March 11, 2024

TO : All Bidders
FROM : Bob Lavey
PROJECT : Nogales High School New Building and Aquatic Center
Project W2110000AR.41
DSA : 03-122782 / File 19-92
SUBJECT : Addendum 3

DRAWING NUMBER: **EA2.2**

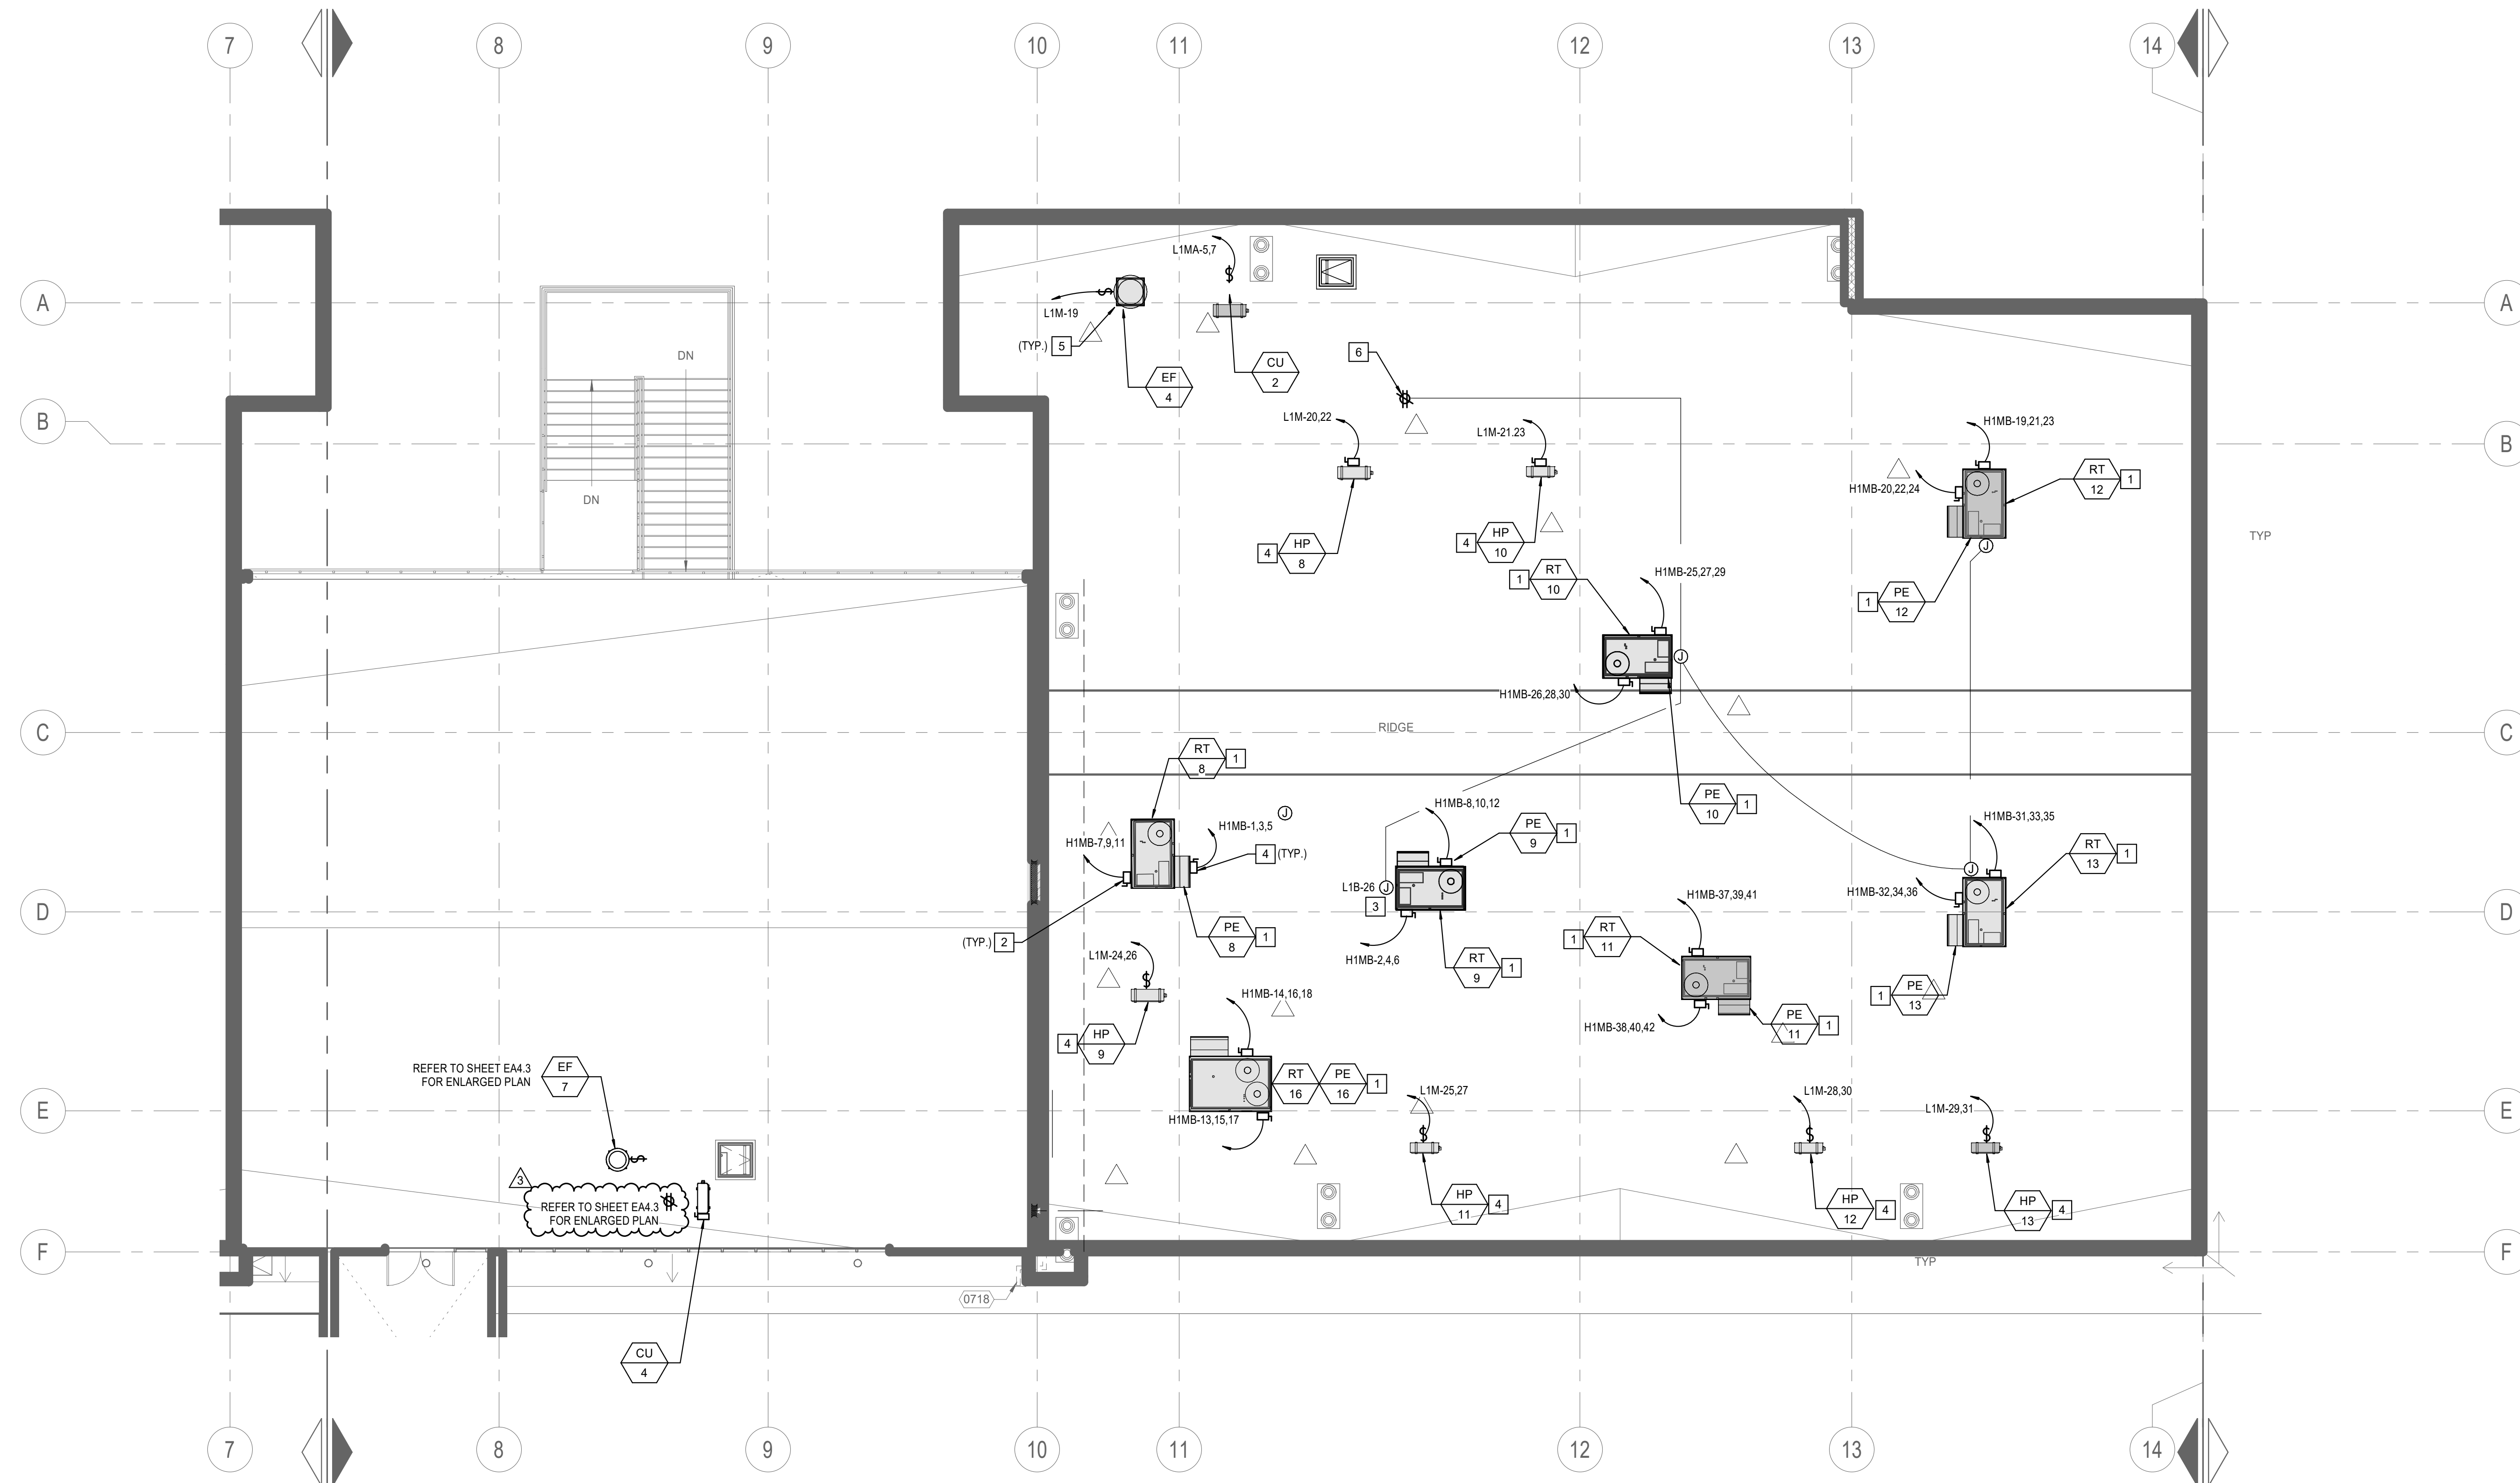
- A. Replace this drawing in its entirety with the attached Drawing EA2.2.
- B. Revise to show future Musco equipment in Team Storage Room per the attached Drawing EA2.2.
- C. Added receptacles to the Storage Rooms per the attached Drawing EA2.2.
- D. Added conduit and wire sizing to Storage Room per the attached Drawing EA2.2.
- E. Added note for wall mounted pullboxes per the attached Drawing EA2.2.
- F. Added notes for spare conduits to future Musco poles per the attached Drawing EA2.2.
- G. Added pullbox sizing per the attached Drawing EA2.2.

DRAWING NUMBER: **EA4.3**

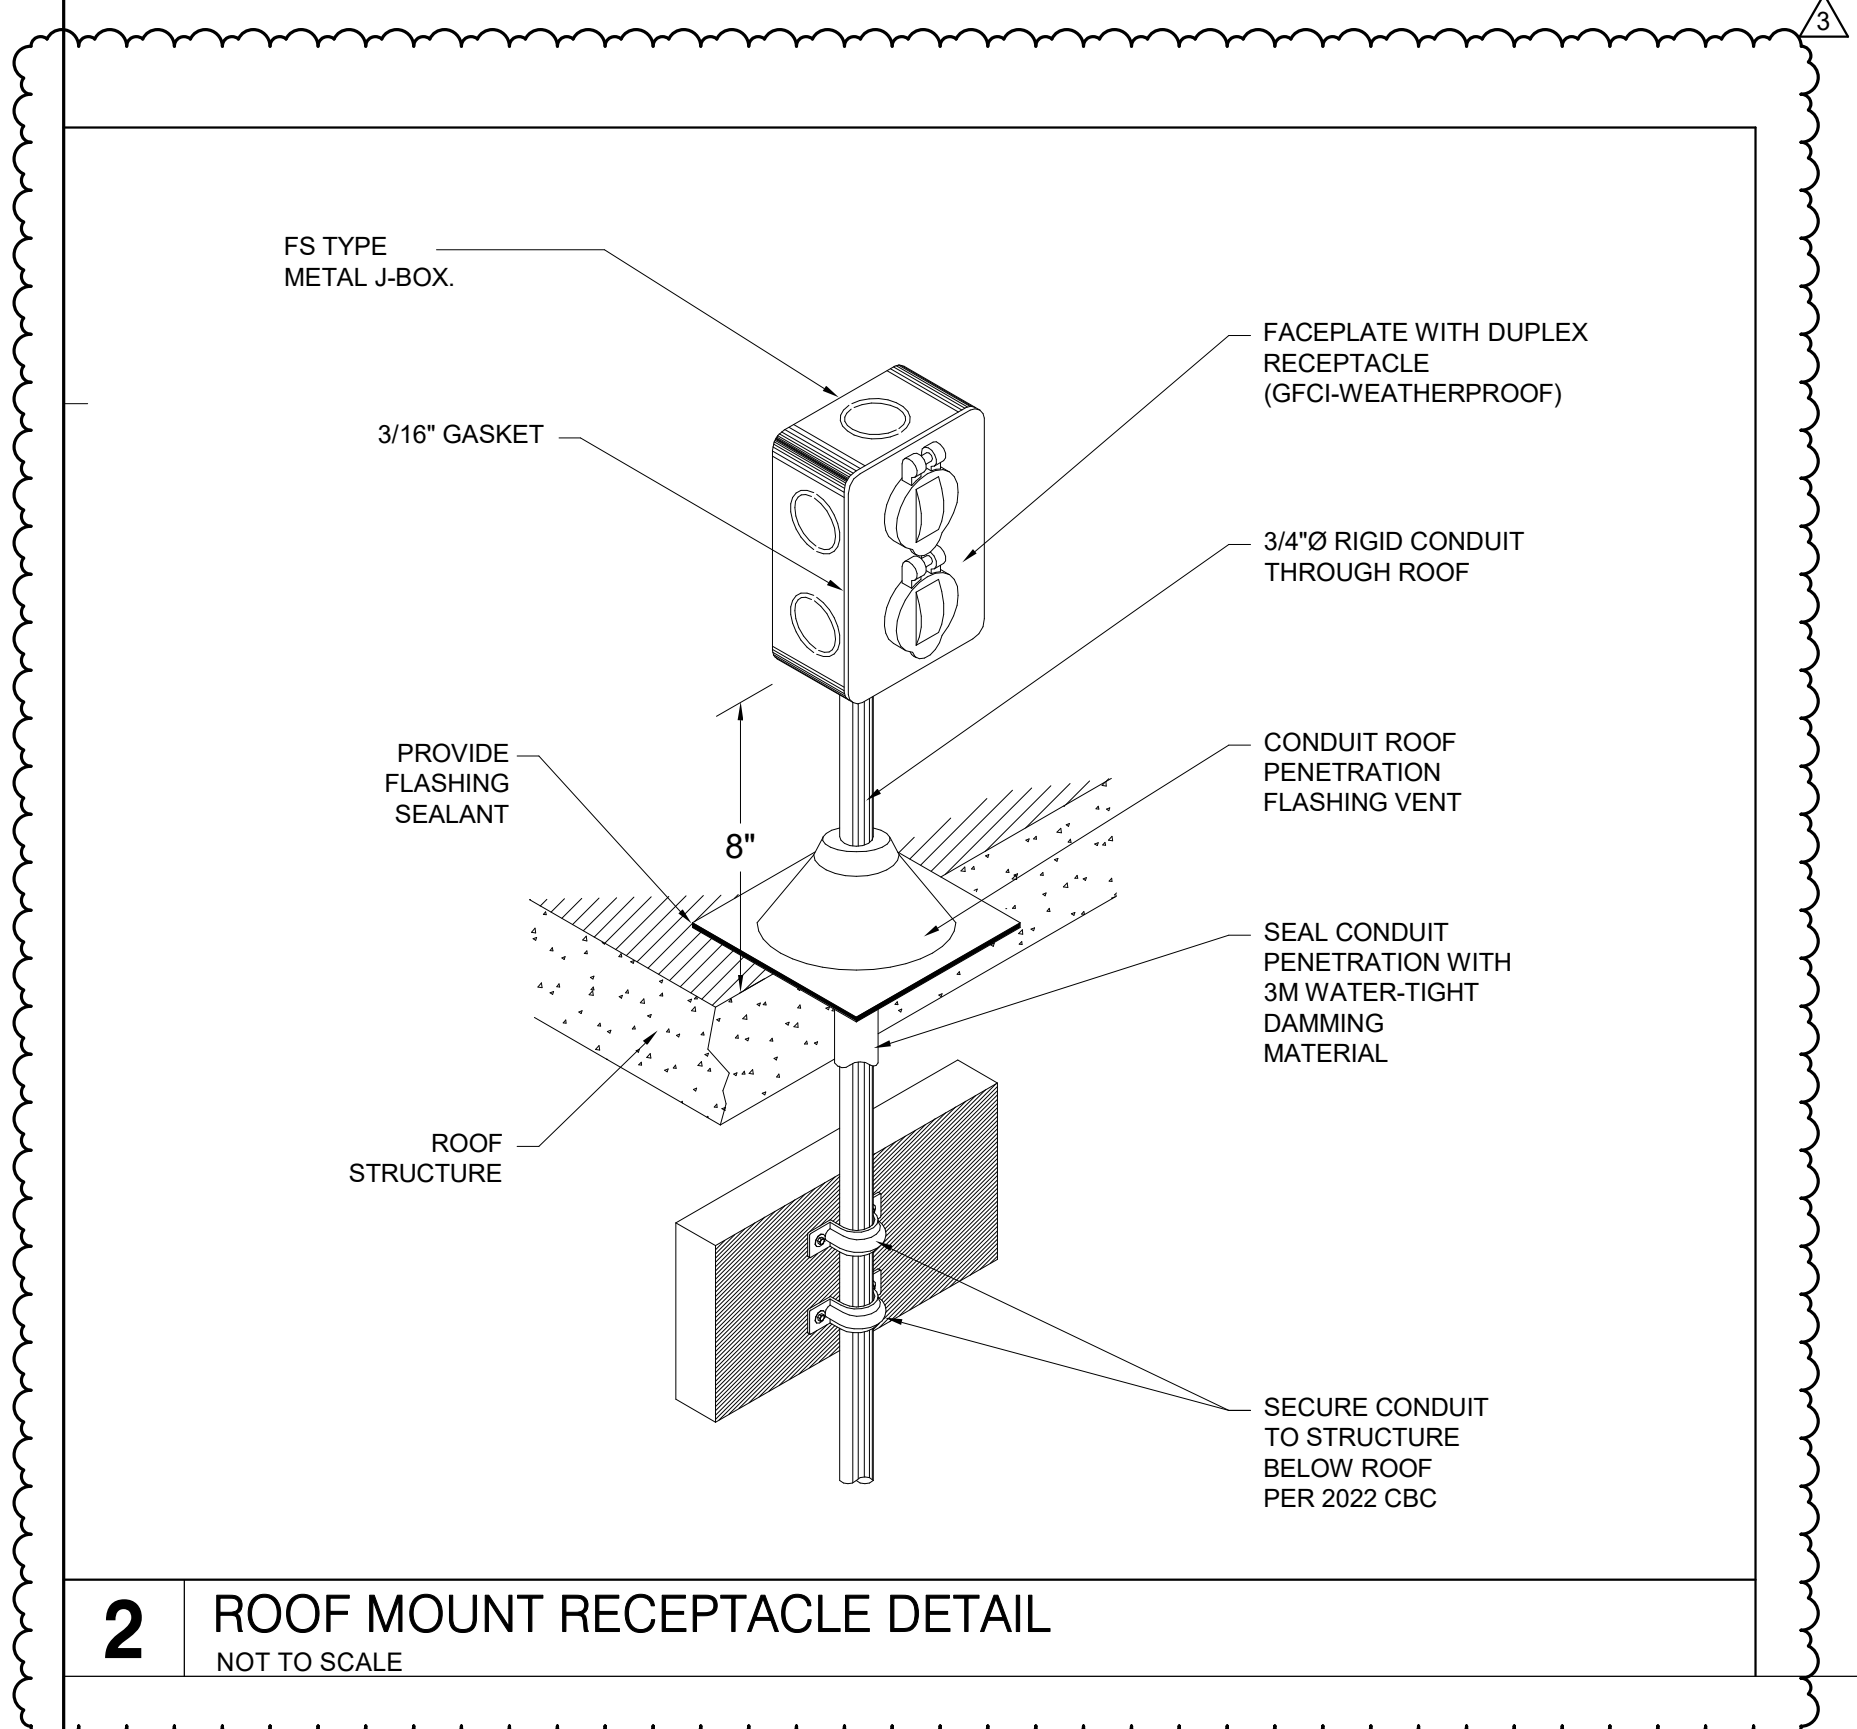
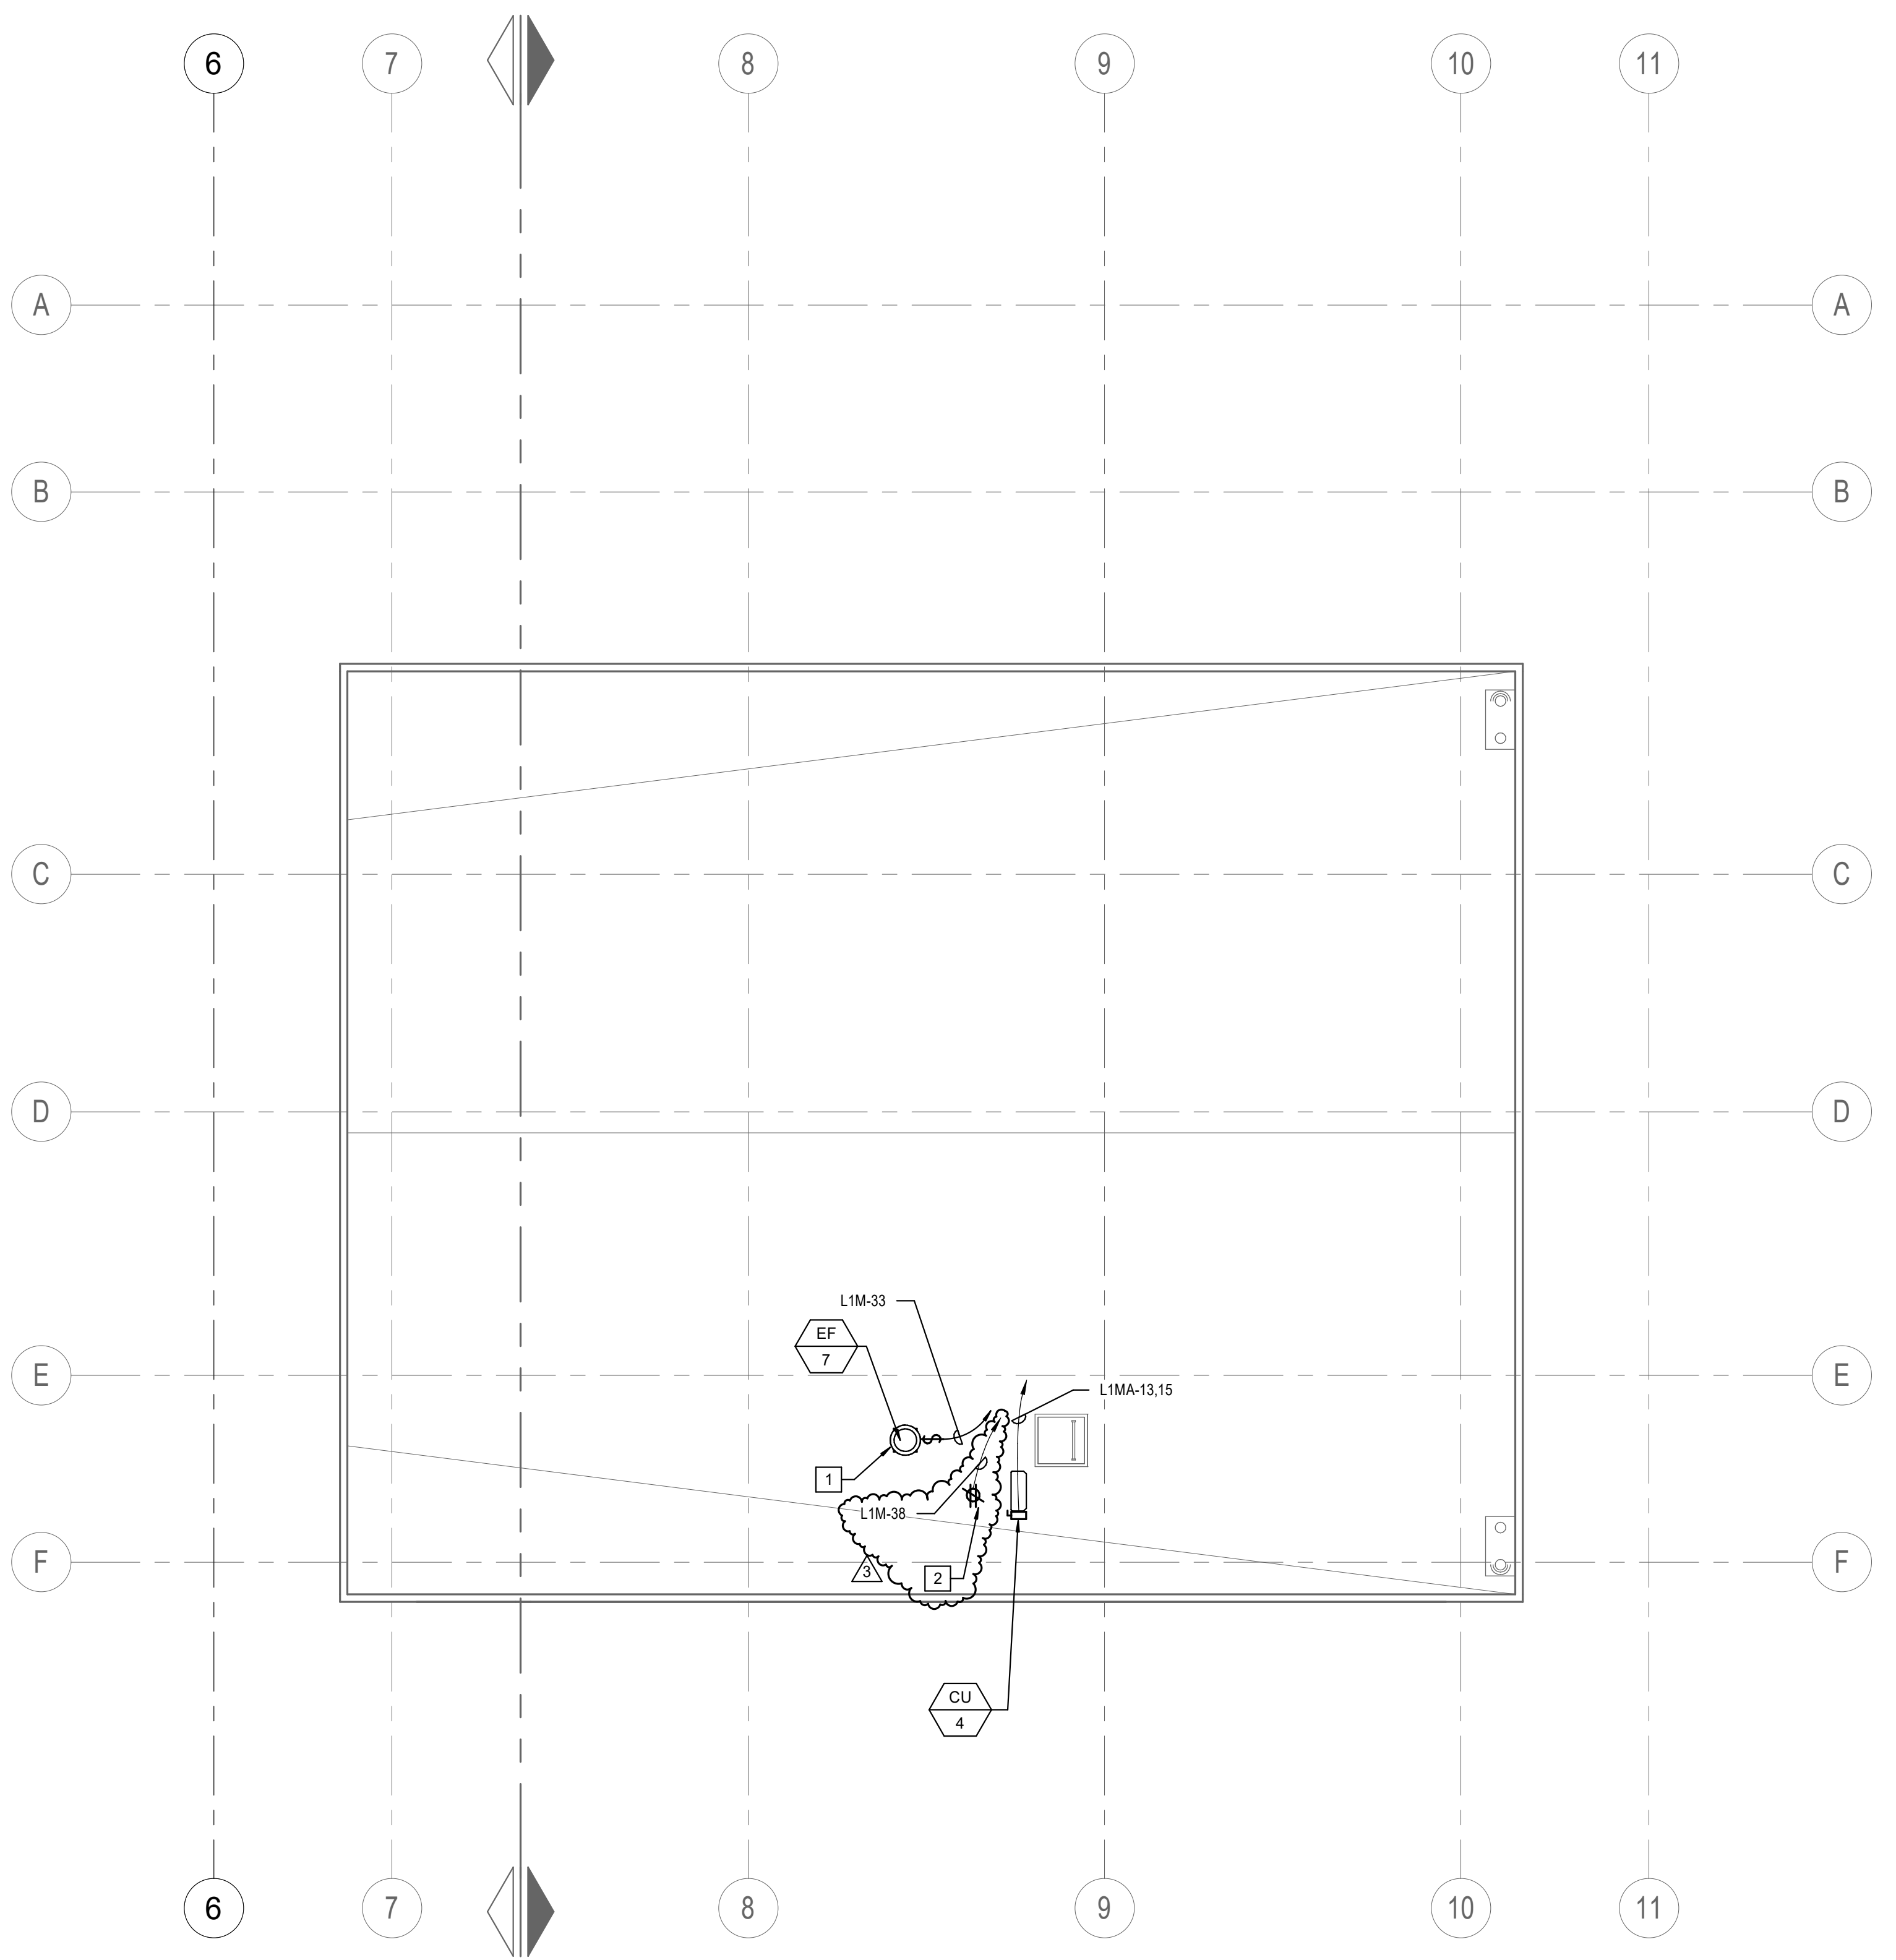
- A. Replace this drawing in its entirety with the attached Drawing EA4.3.
- B. Add roof receptacle and Keynote 2 per the attached Drawing EA4.3.
- C. Add detail for roof receptacle mounting per the attached Drawing EA4.3.
